Application/Control Number: 10/580,551

DETAILED ACTION

Figure i- Applicants invention.

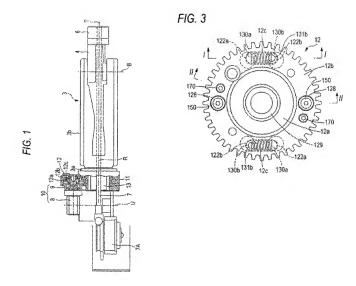
1. Figures 8-10 should be designated by a legend such as —Prior Art-- because only that which is old is illustrated. See MPEP § 608.02(g). Corrected drawings in compliance with 37 CFR 1.121(d) are required in reply to the Office action to avoid abandonment of the application. The replacement sheet(s) should be labeled "Replacement Sheet" in the page header (as per 37 CFR 1.84(c)) so as not to obstruct any portion of the drawing figures. If the changes are not accepted by the examiner, the applicant will be notified and informed of any required corrective action in the next Office action. The objection to the drawings will not be held in abevance.

Applicant claims an arm mechanism for a robot comprising:

An arm portion of which one-end side in a longitudinal direction is supported, and while other-end side in the in the longitudinal direction is rotatable around a rotation axis elongating in the longitudinal direction with respect to said one-end side:

- A driving portion being apart from the rotation axis and disposed in said one-end side of said arm portion, in which a reduction gear is coupled to an output shaft of a driving motor;
- A driven gear, rotatable around the rotation axis, and connected to said other-end side of said arm portion:
- A passing hole which is disposed along the rotation axis and passing through said driven gear in a manner such that said passing hole is opened to an outside of said one-end side of said arm portion so as to communicate with said other-end side of said arm portion; and
- A scissors gear which is disposed on the output shaft of said reduction gear so as to mesh with said driven gear.
